Project	<b>IEEE 802.16 Broadband Wireless Access Working Group</b> < <a href="http://ieee802.org/16">http://ieee802.org/16</a> >	
Title	Changes to Working Draft Document for Conformance of Same PHY Profile Processes and the CX_CC concept	
Date Submitted	<b>2006-09-28</b>	
Source(s)	John Sydor Shanzeng Guo Communications Research Centre  Ottawa, Canada K2H 8S2	Voice: 613-998-2388 Fax: 613-990-8369 <a href="mailto:john.sydor@crc.ca">john.sydor@crc.ca</a>
Re:	Revision to IEEE C802.16h-06/092	
Abstract	Changes to conform with Draft Document	
Purpose	revision	
Notice	This document has been prepared to assist IEEE 802.16. It is offered as a basis for discussion and is not binding on the contributing individual(s) or organization(s). The material in this document is subject to change in form and content after further study. The contributor(s) reserve(s) the right to add, amend or withdraw material contained herein.

**Changes to Working Draft Document for conformance of Same PHY Profile Processes and the CX\_CC concept**

Figure h32 CCD Process

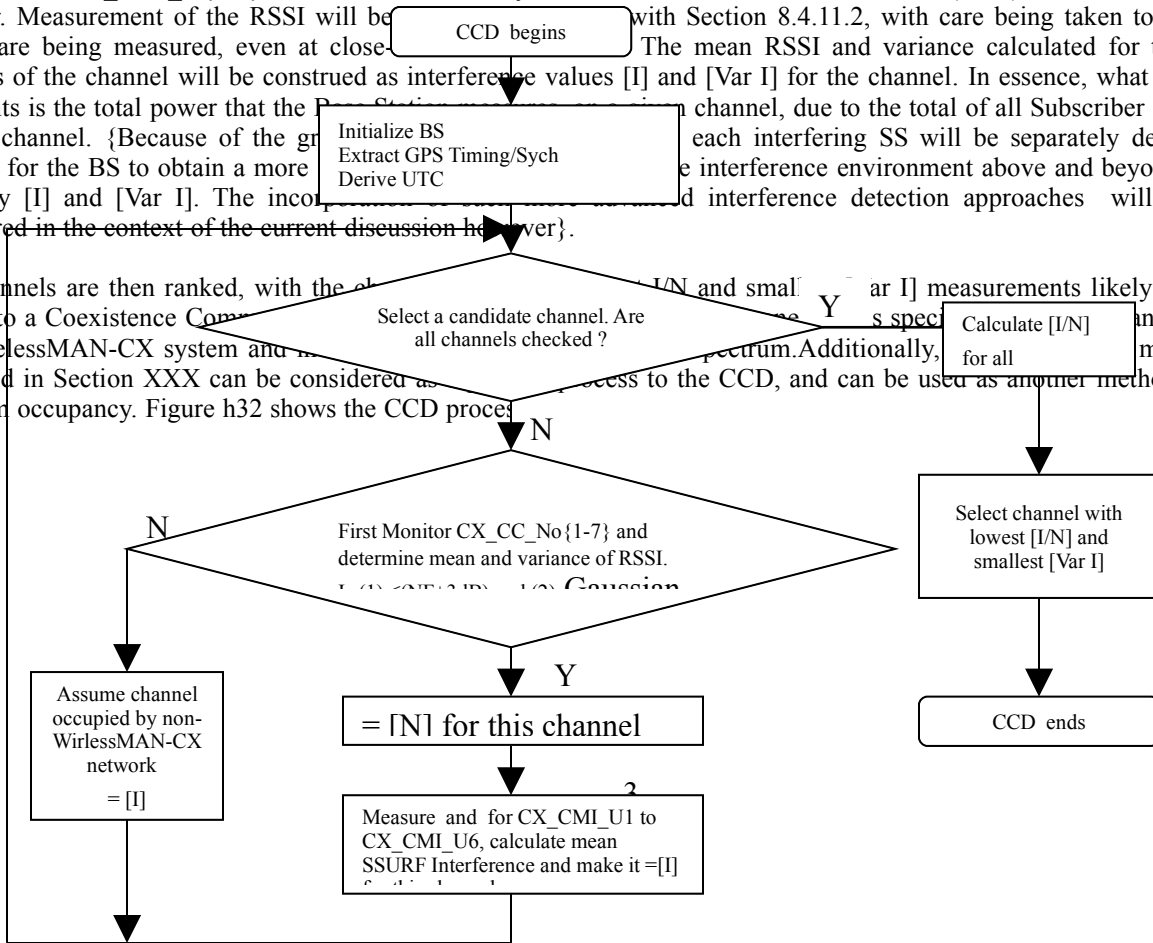
Delete the current Section 15.3.2.2 and insert the following new section:

15.3.2.2 Candidate Channel Determination (Using GPS/UTC Synchronized CMI and Common Profile)

Candidate Channel Determination (CCD) is the process used by WirelessMAN-CX systems (conforming to a synchronized CMI and common profile) where the base station monitors a band to which it has access and selects, within that band, a channel having minimal use and occupancy by neighboring wireless systems. This process is used, for example, by an IBS prior to undertaking entry into a Coexistence Community. Since a base station can only receive uplink traffic, this process relies on the monitoring uplink transmission intervals and the measurement of interference signal power [I] and noise power [N]. Each candidate channel will be ranked in terms of its (I/N) ratio. Those channels with the lowest ratio or ideally a ratio of 1 will be selected for use by the base station and be candidates for entry by an IBS, since such channels will have the lowest amount of discernable activity on them, hence likely have lower interference.

The channels are then ranked, with the channels having the lowest [I/N] and smallest [Var I] measurements likely selected for IBS entry into a Coexistence Community. The process of operation for monitoring process described in Section XXX can be considered as an alternative method of ascertaining spectrum occupancy. Figure h32 shows the CCD process.

Figure h33. IBS community entry process for Same PHY Systems using CX\_CC CMI signaling .

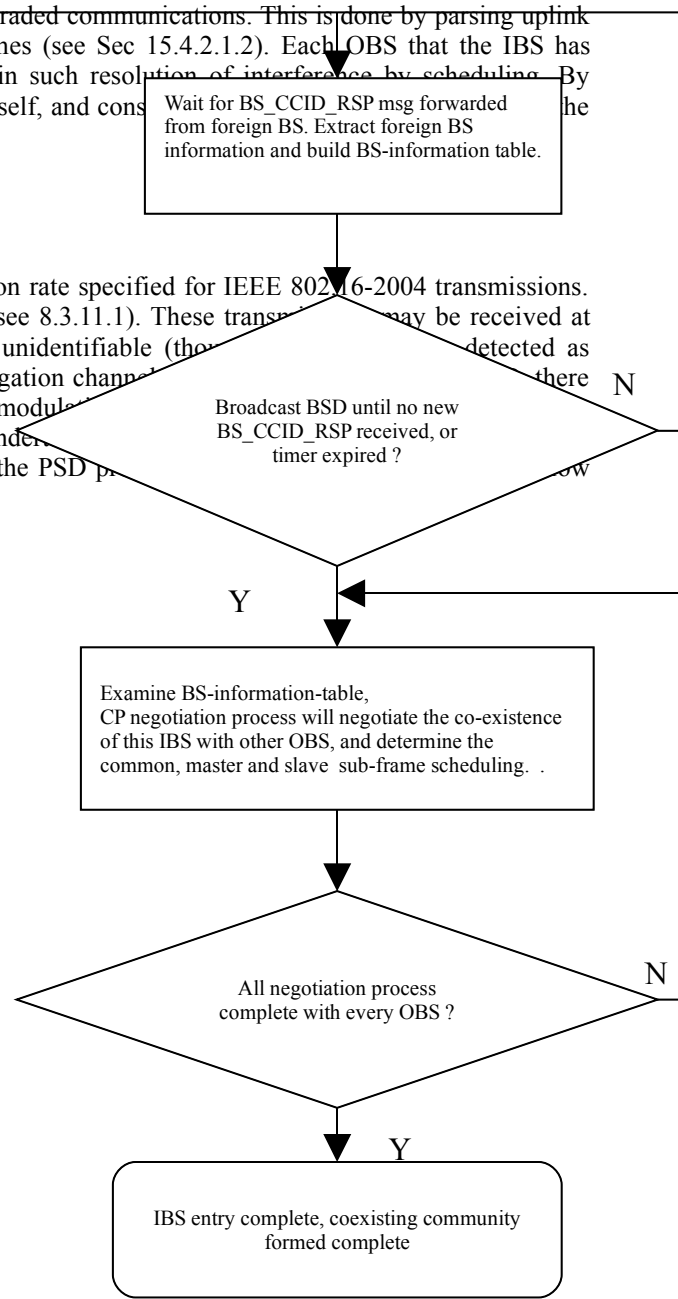
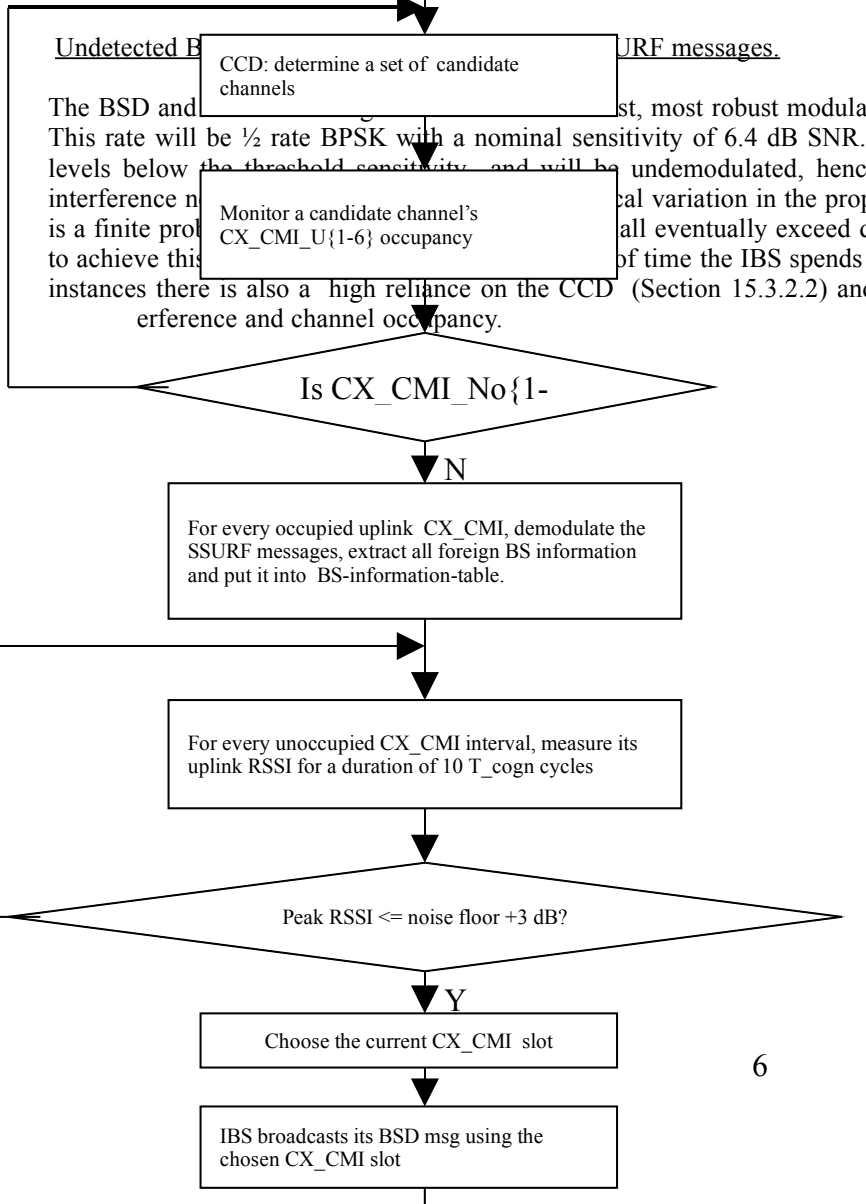
*Delete the current Section 15.3.2.3 and insert the following new section:*

**15.3.2.3 Entry of a new BS into a Interference Neighborhood and the Creation of a Coexistence Community Using CX\_CC**

In applications where the CX\_CMI intervals are synchronized to the CX\_CC and are used with systems having a common (same) PHY profile, entry of a new Base Station (IBS) will be undertaken in 4 steps, with the IBS:

Prior to entry into a Community of Operating Base Stations (OBS) it is assumed that the IBS will have undertaken the Candidate Channel Determination (Section 15.3.2.2) process and has selected a candidate channel and has no operational SS yet deployed. It is assumed that the IBS is deployed within an Interference Neighborhood, ie: active interference from existing operating systems is present. The IBS entry process is shown in Figure h33. Figure h34 shows aspects of the entry procedure with signaling.
